Section 1: Process Overview

Manual 14B: PJM Region Transmission Planning Process
Section 2: Regional Transmission Expansion Plan Process

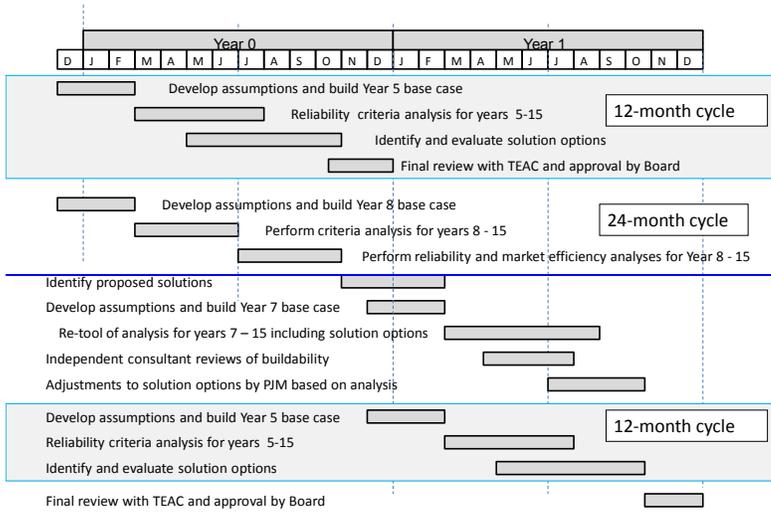
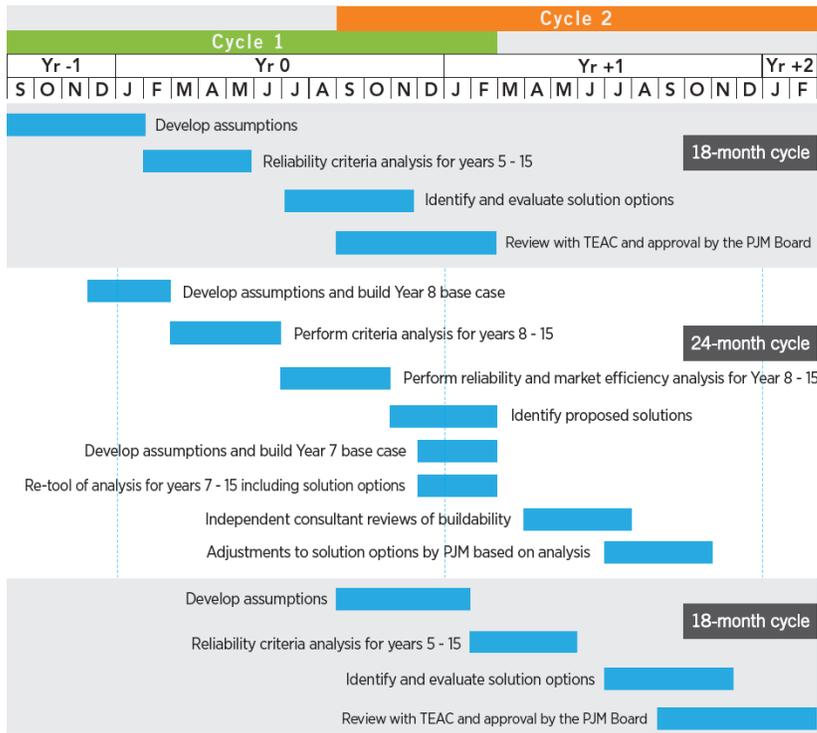
The 24-month planning process is made up of [overlapping 18-month planning cycles \(Refer to Exhibit 1\)](#) ~~to two similar 12-month planning cycles~~ to identify and develop shorter lead-time transmission upgrades and one 24-month planning cycle to provide sufficient time for the identification and development of longer lead-time transmission upgrades that may be required to satisfy planning criteria. Consistent with the requirements of the NERC TPL Reliability Standards the 24-month planning process includes both near-term (years one through five) and long-term (years six through fifteen) assessments of the transmission system as described below.
